To: City of Phoenix Planning Commission

- **From:** Enrique Bojórquez-Gaxiola Planner II – Village Planner
- Subject: ITEM NO. 10 (Z-3-20-7) NORTHWEST CORNER OF 15TH AVENUE AND VINEYARD ROAD

This memo is to address the South Mountain Village Planning Committee recommendation, a request by the applicant regarding the location of open space areas within the proposed residential subdivision, to correct a typo in a stipulation pertaining to an avigation easement and an additional stipulation for an executed Proposition 207 waiver.

Revised Site Plan with Planning and Development Department annotations (Date Stamped November 19, 2020)

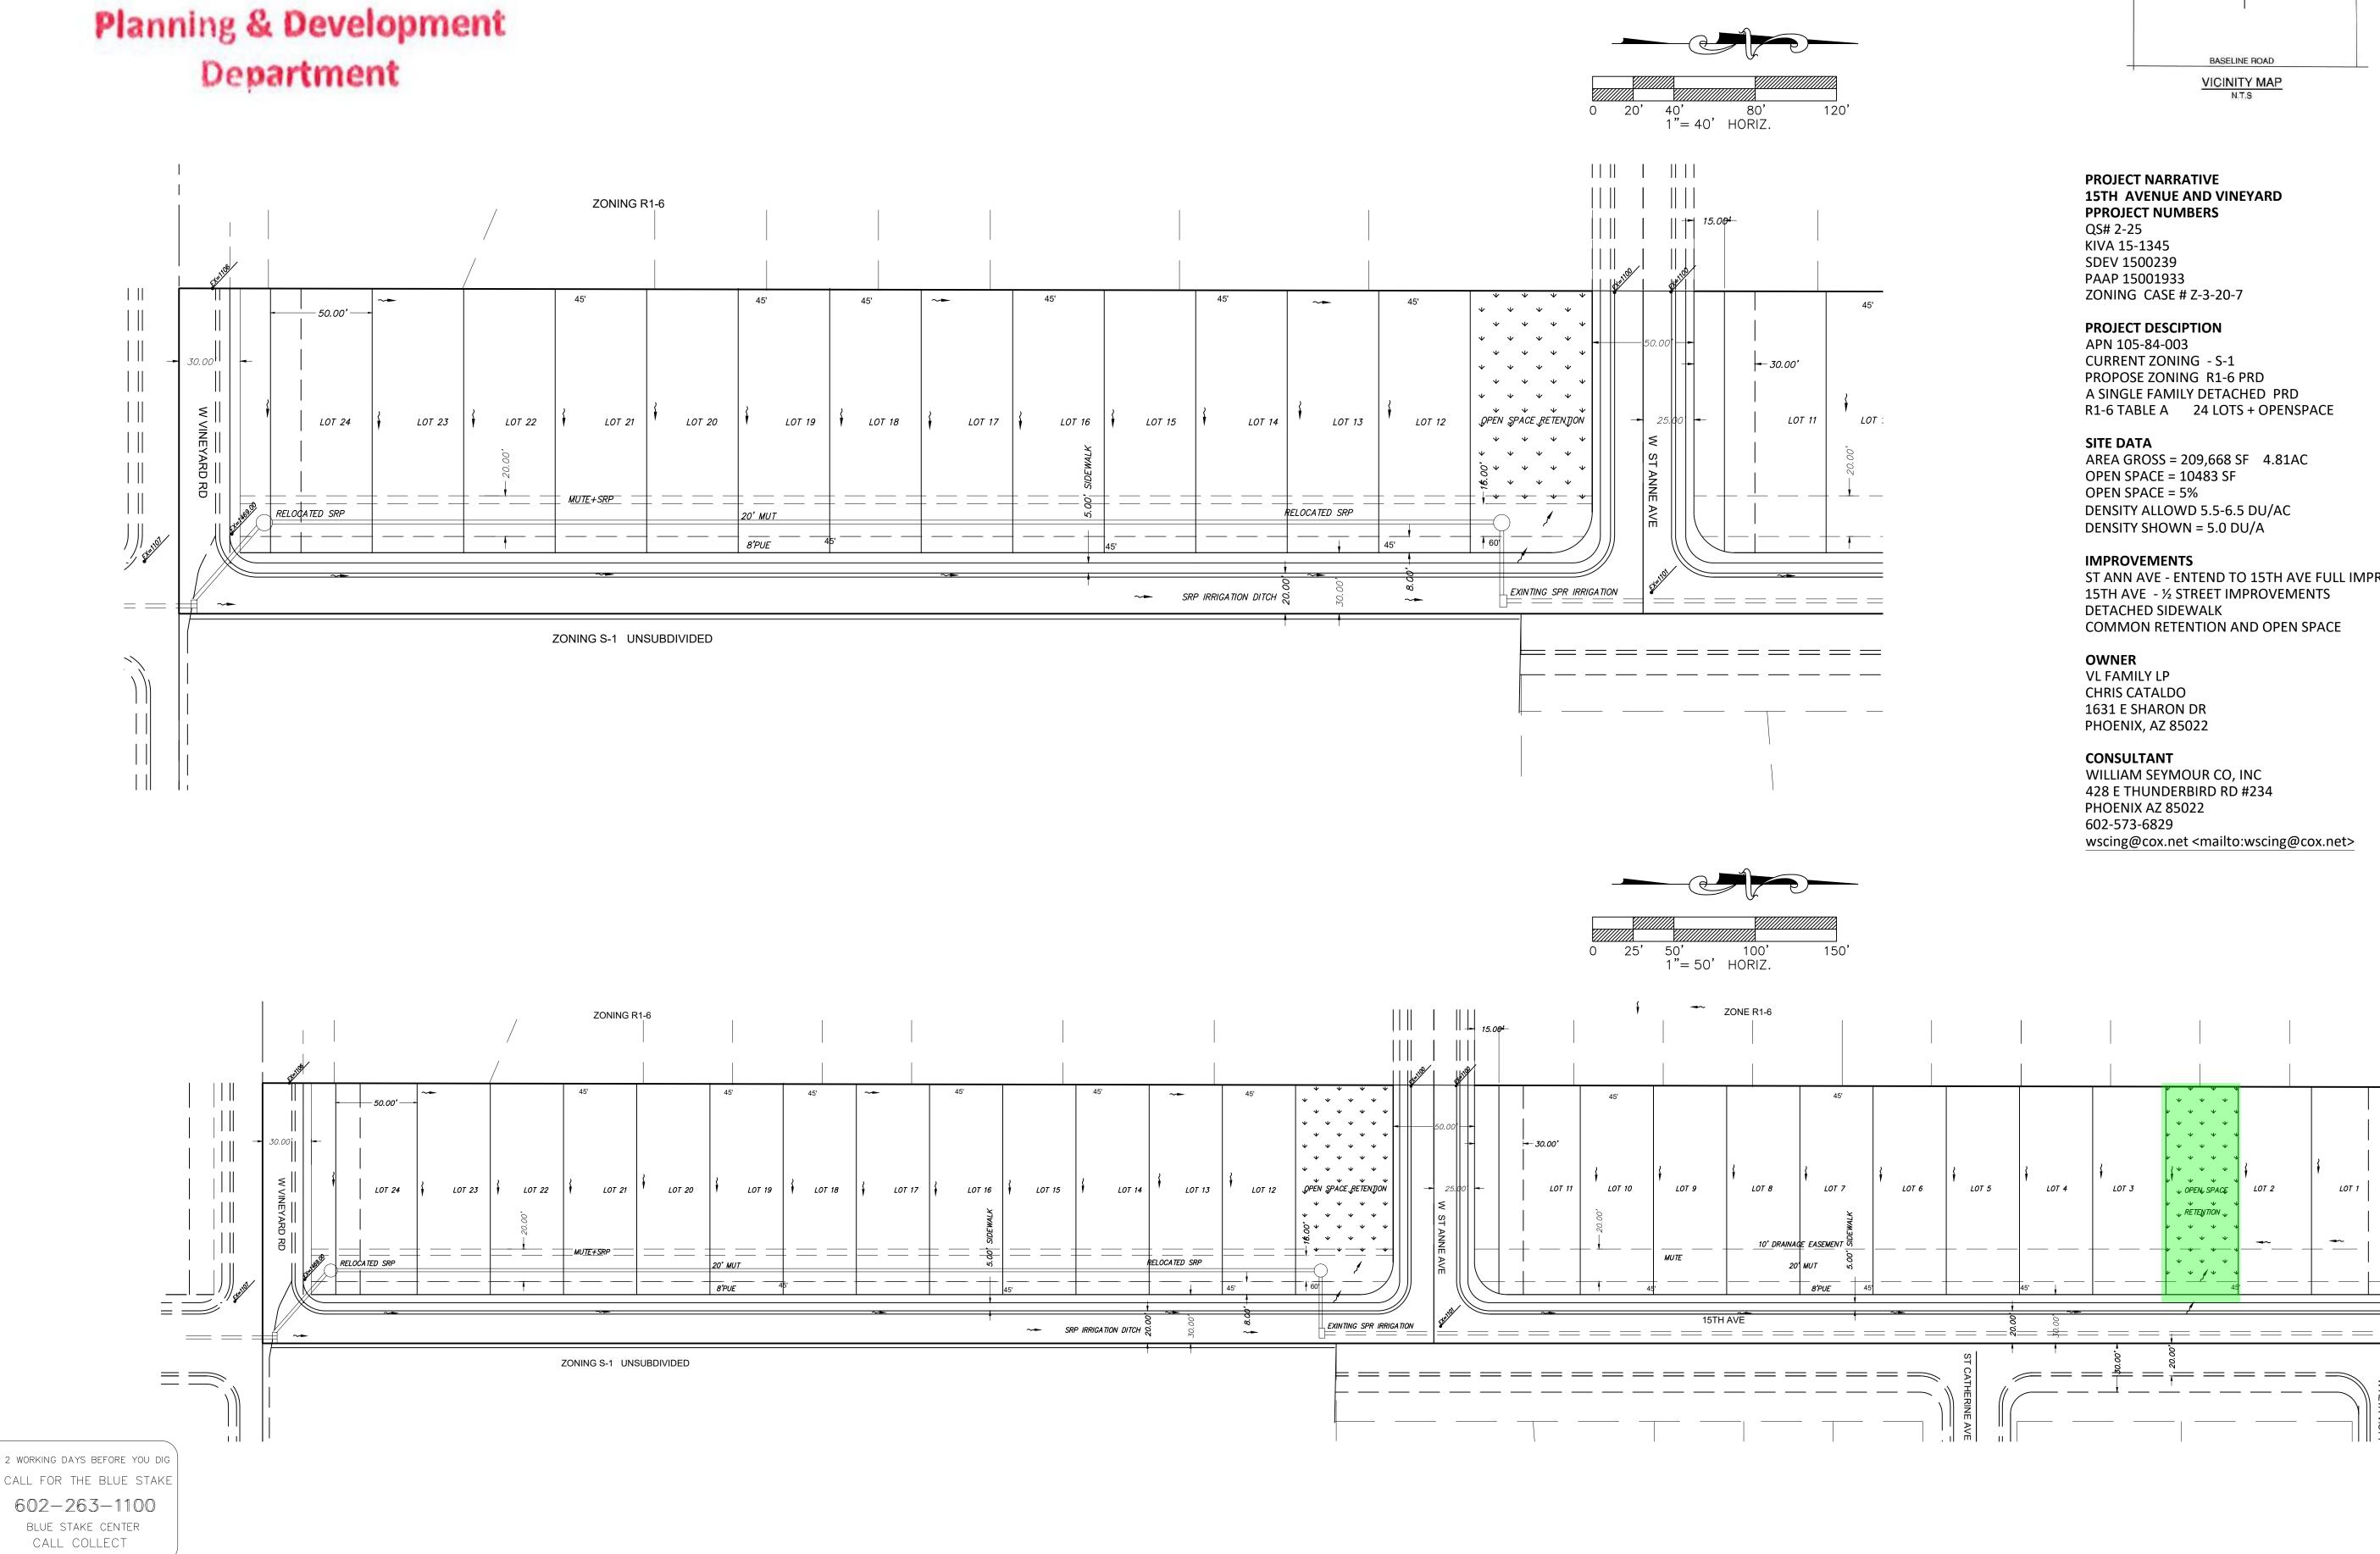
After the November 10, 2020 meeting, staff learned that drainage on the site flows generally on a northward direction, thus relocating the open space area north of Lot 1 to the location where Lot 11 is shown in the conceptual site plan would require an engineering solution consistent with the City of Phoenix Drainage Ordinance to redirect the drainage on the site or seek relief from Phoenix City Code via a Technical Appeal. Staff recommends the following modification to Stipulation No. 3 to allow for flexibility in locating the open space area in an alternate location north of the site where adjacent to residential lots to promote safety. These changes are reflected in the revised Stipulation No. 3 below.

- 3. -A TWO centrally located open space areaS shall be developed ALONG ST. ANNE AVENUE and include the following amenities and elements at a minimum, distributed between the open space area(s), as approved by the Planning and Development Department. WHERE UTILITY OR DRAINAGE ISSUES ARISE, ONE OF THE OPEN SPACE AREAS CONTAINING RESIDENTIAL AMENITIES AND ELEMENTS MAY BE LOCATED WITHIN THE NORTH 400 FEET OF THE SITE, AS APPROVED BY THE PLANNING AND DEVELOPMENT DEPARTMENT.
